PREVOST

MI12-48

DATE :	DECEMBER 2012	SECTION :	05 - Cooling
SUBJECT :	4-INCH OD TURBO OUTLET PIPE – CLEARANCE WITH CLOSE SUPPORT BRACKET

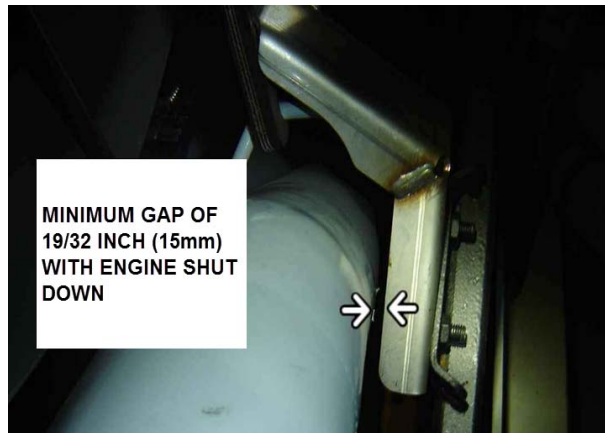
2) The picture below shows the area where interference between the 4-inch OD turbo outlet pipe and the close support bracket may be present.

3) With the engine shut down, the minimum gap should be about 19/32 inch (15 mm).

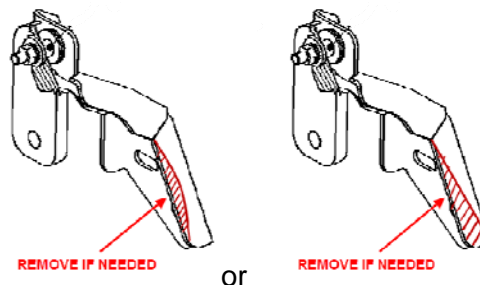
4) If evidence of rubbing is found, remove the support bracket and cut a part of the support bracket out as shown (as per image at left or at right as needed) and trim sharp edges.
